REPORT AMENDED BY STAFF 1-22-87
CITY PLANNING COMMISSION

- APPLICATION:**
- A. Negative Declaration
 - B. General Plan Amendment from Residential to General Commercial
 - C. 1984 North Sacramento Community Plan Amendment from Residential 4-8 du/acre to Retail/General Commercial
 - D. Rezone 1.29 vacant acres from Single Family (R-1) to General Commercial-Review (C-2-R) zone
 - E. Plan Review of a 9,600 square foot retail and wholesale battery storage and sales building

LOCATION: Southeast corner of Bell Avenue and Marysville Boulevard

EXHIBIT A-1
SITE PLAN
ORIGINAL

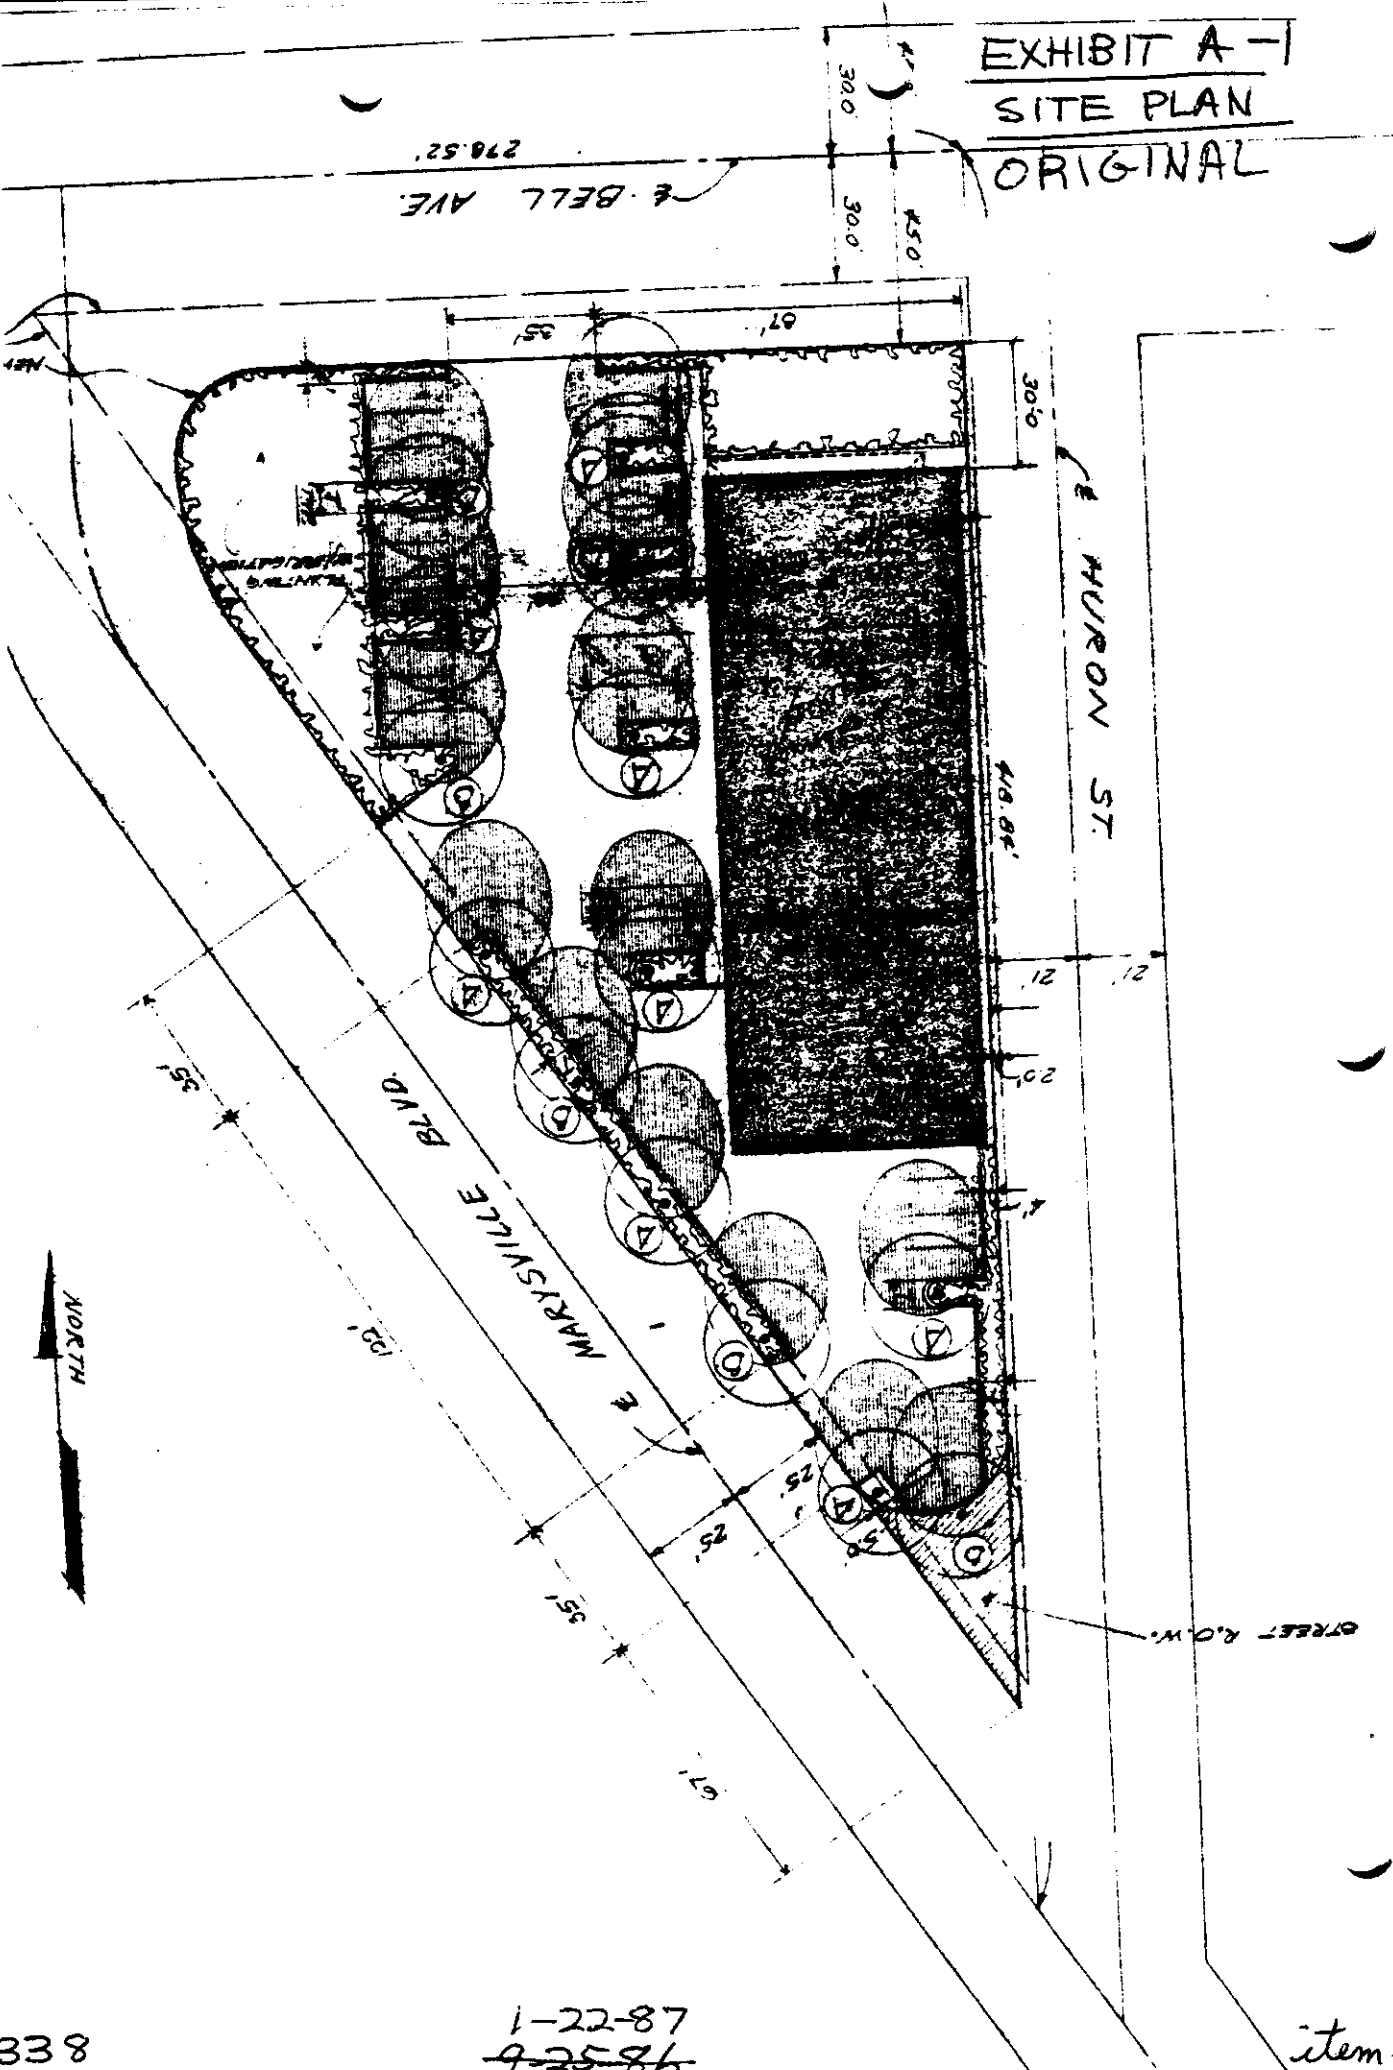
Parking requirements are based upon two criteria - zoning and land use. In the C-2 zone, the General Commercial parking requirement is one space for each 500 square feet of gross floor area. The applicant's plans show 20 spaces and one handicapped space, based upon the one to 500 ratio. His use, however, does not require as much parking. For warehouse and wholesale activities one space is required for each 1,000 square feet of warehouse area. When the project is redesigned to address concerns listed in the next section, parking calculations may require revision based upon type of land use. The proposed convenience market parking ratio is 1:250 and would require 13 parking spaces based on 3,240 square feet.

EXHIBIT A-2
 SITE PLAN
 REVISED 1-9-87

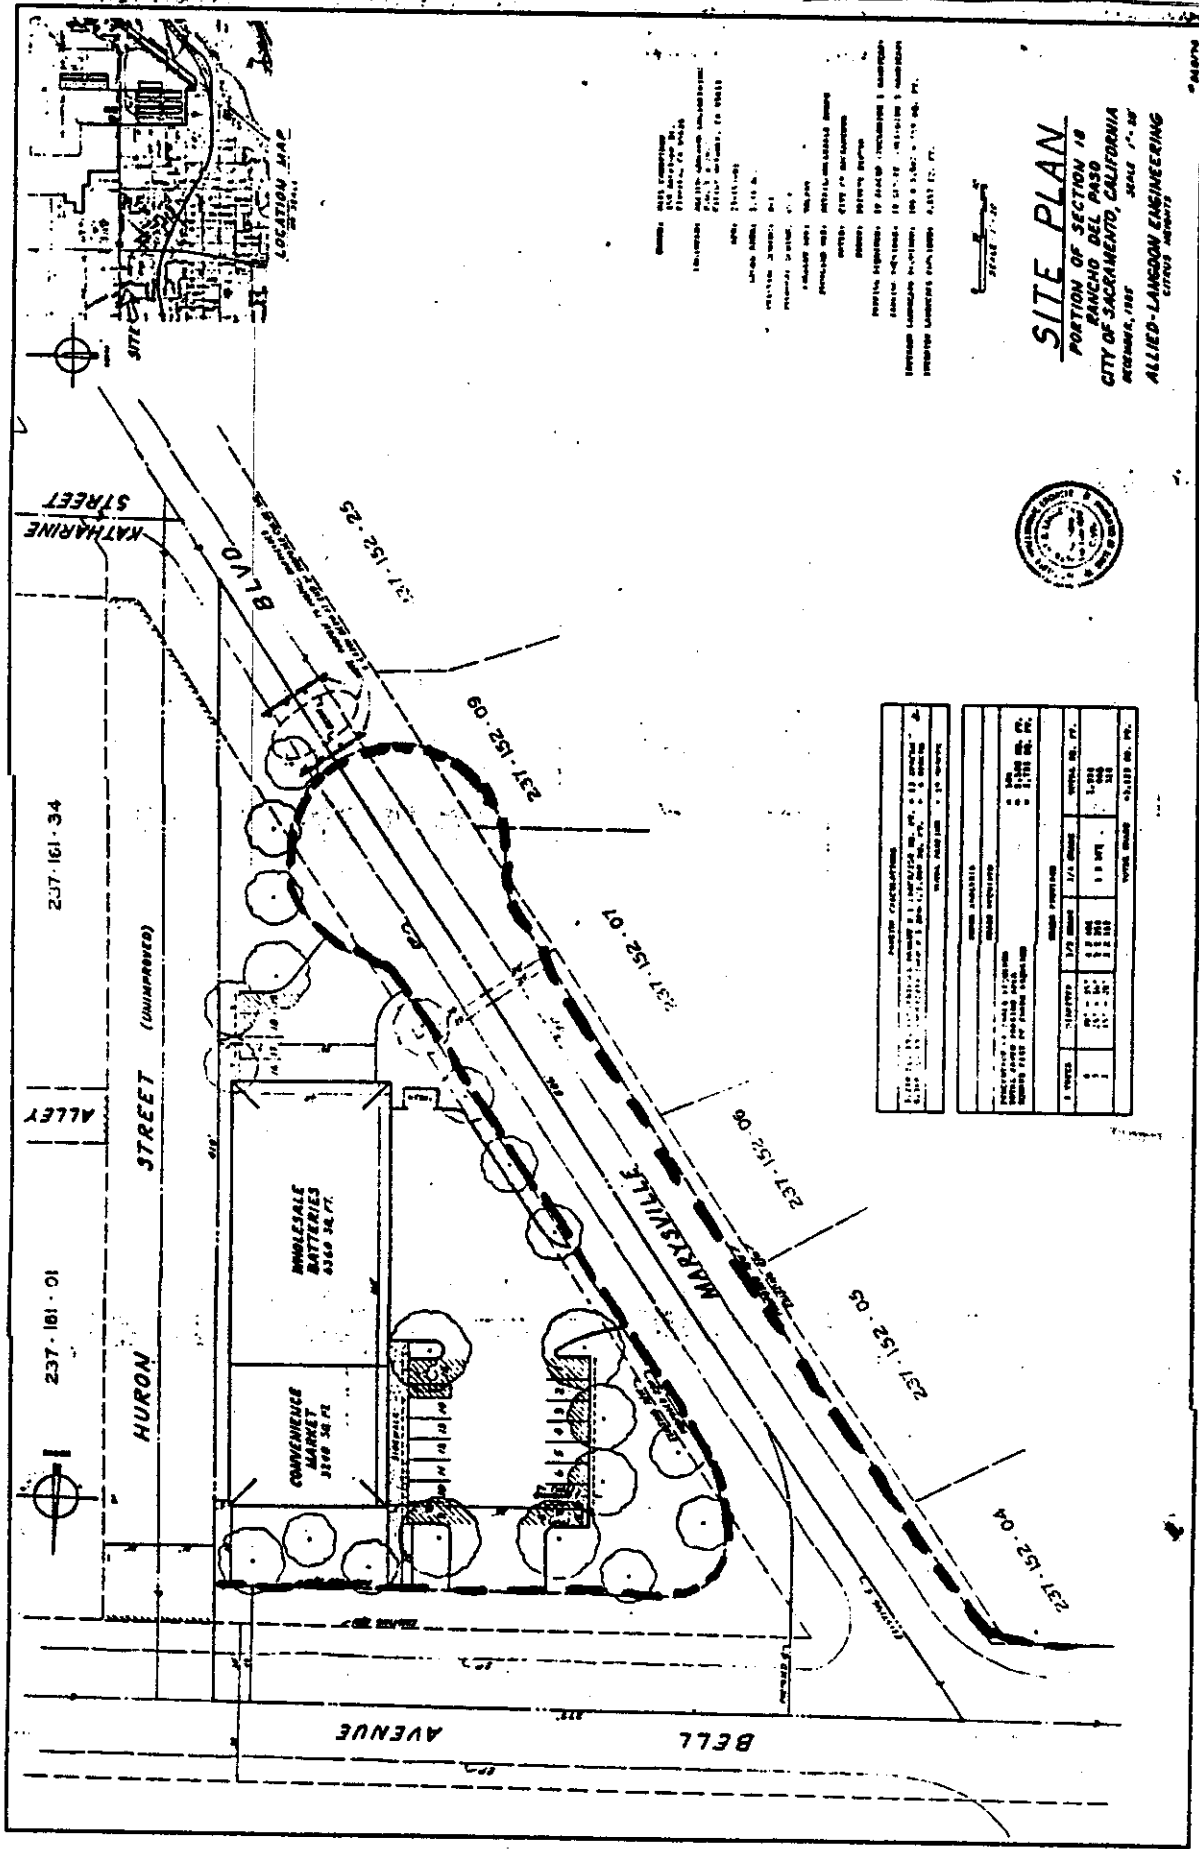
The applicant's proposed landscape plans should show a landscape setback along Bell Avenue of 25 feet. This would eliminate four parking spaces but allow establishment of adequate area for a four foot high landscape berm along Bell Avenue.

Use of minimum 15 gallon evergreen trees is recommended on the landscape plan with trees on 20 foot centers along the public street frontage. Several trees should be planted at the north end of the building in the front yard area south of Bell Avenue (refer to Exhibit E for staff modified site plan).

outdoor dumpsters are to be located outside trash enclosure areas. Staff recommends that the trash enclosure be relocated to not be visible from Marysville Boulevard.

1. Abandon Huron or provide for widening, radii and setbacks.
2. More cul-de-sac north to approximately the north driveway.
3. Show vehicle and cargo doors on plan.
4. Driveways must have 90° or radial approach to public street.
5. "Autos Only" driveway should not be 35 feet wide. (Applicant revised the proposed site plan after submitting revised plans to the City Traffic Engineer. The above comments were made on December 23, 1986 on the revised site plan.)

3. Parking lot layout shall be revised to show 6,400 square feet of warehouse use at one space per 1,000 square feet or six spaces and retail-commercial use at one space per 250 square feet for 3,200 square feet, resulting in 13 spaces for a total of 19 required spaces and one handicapped space. Bicycle storage facilities should be shown on the site plan.

4. The Design Review Board shall review and approve revised building elevations reflecting a commercial design prior to issuance of building permits.
5. The applicant shall prepare revised landscape and irrigation plans to show a 25 foot, four foot high bermed landscape setback along Bell Avenue as per Exhibit E for review and approval by the Planning Director prior to issuance of building permits.

12. The applicant shall revise the site plan to the satisfaction of the City Engineer and Traffic Engineer regarding improvements and dedications along Bell Avenue and Marysville Boulevard.

**EXHIBIT B
ELEVATIONS**

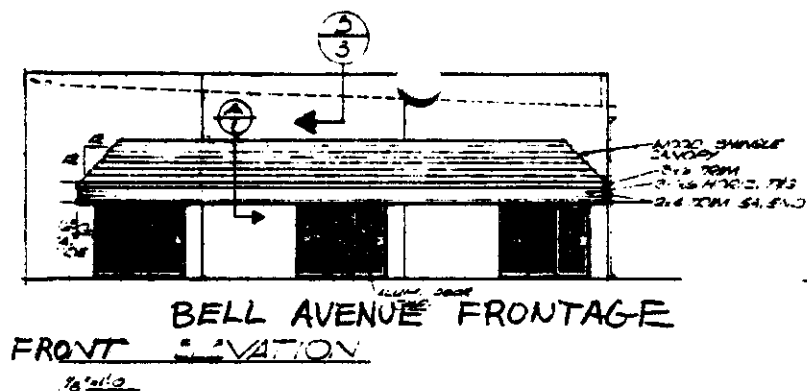
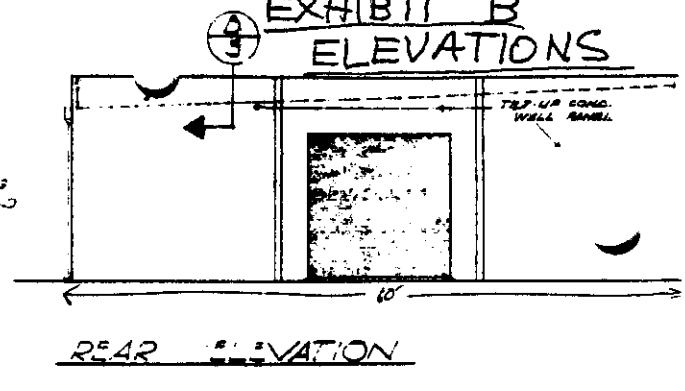
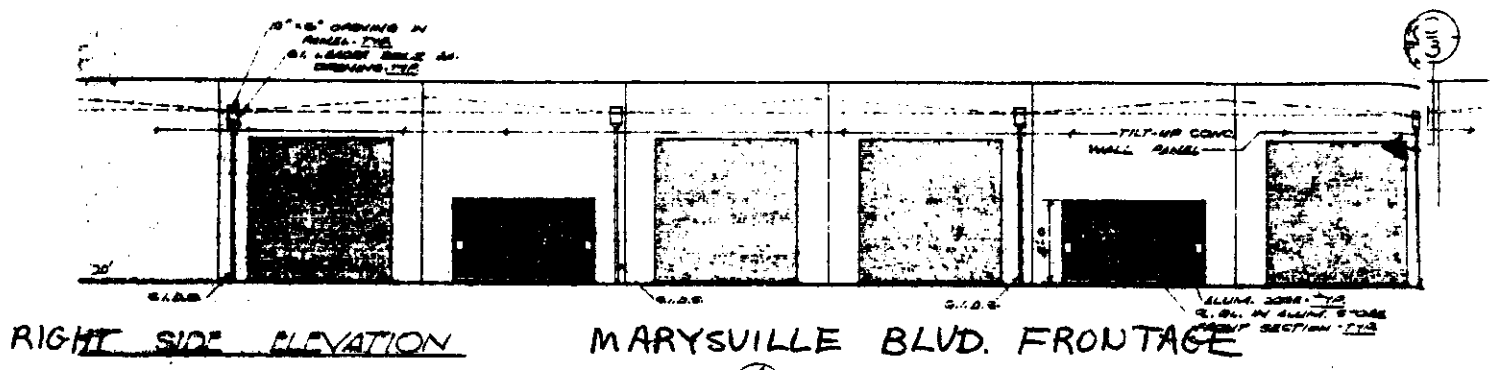
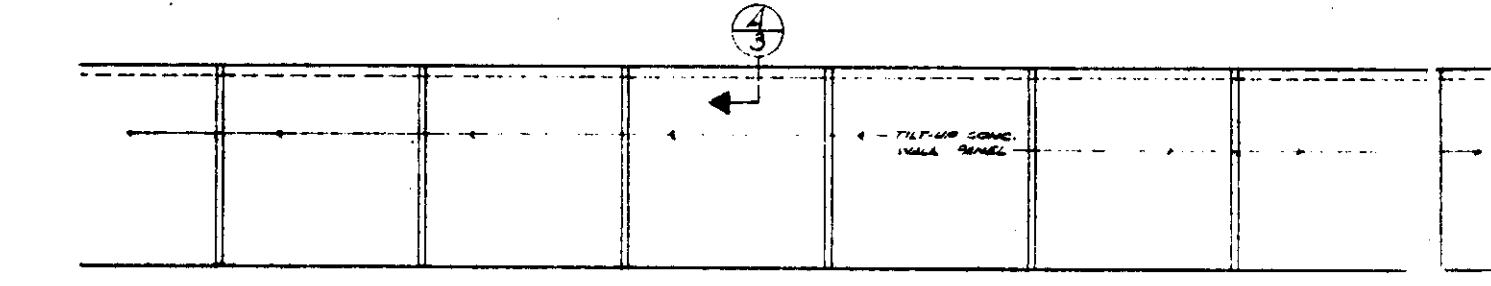
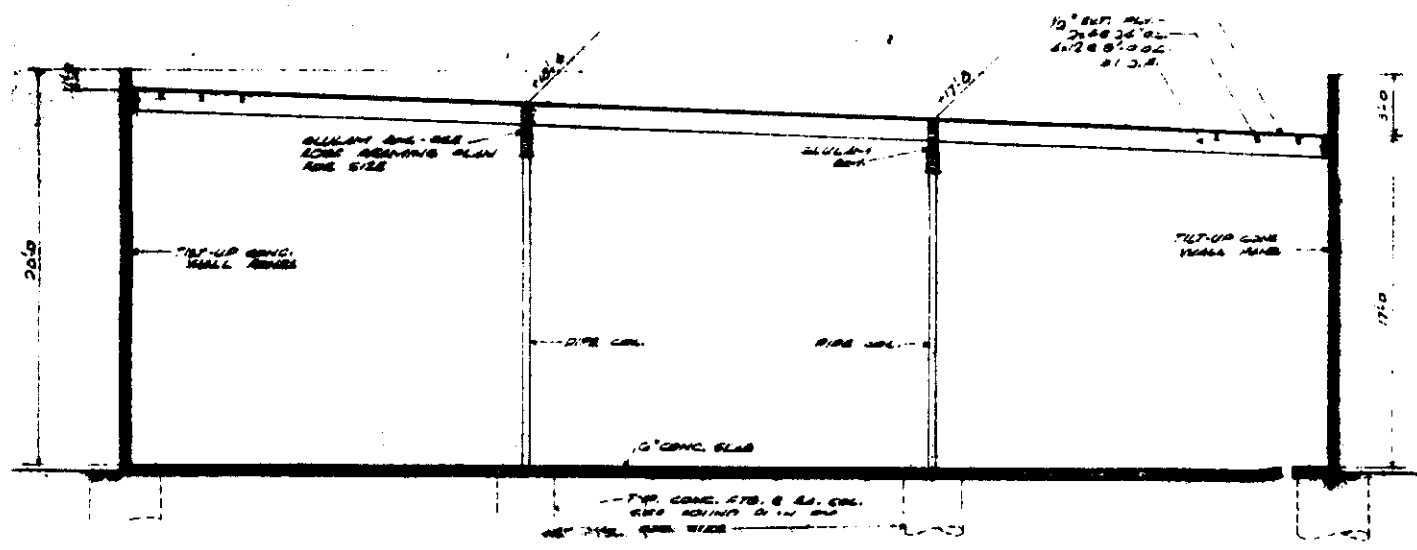
The overall exterior appearance of the building does not reflect a General Commercial use, rather a warehouse use. Staff is concerned that the lack of architectural variation and relief to the building will negatively affect the area. It is recommended that the applicant revise the elevations to reflect the following modifications:

1. Provide revised elevations for commercial and warehouse use:

Overall, the staff is dissatisfied with the elevations and recommends the applicant submit revised elevations to the Design Review Board for approval prior to submittal of building permits. The buildings should reflect a commercial theme that is compatible with the residential uses.

The five foot building setback along the east property line should be increased to six feet with increased landscaping and trees to provide a buffer adjacent to the wall or the alternative is to redesign the eastern elevation.
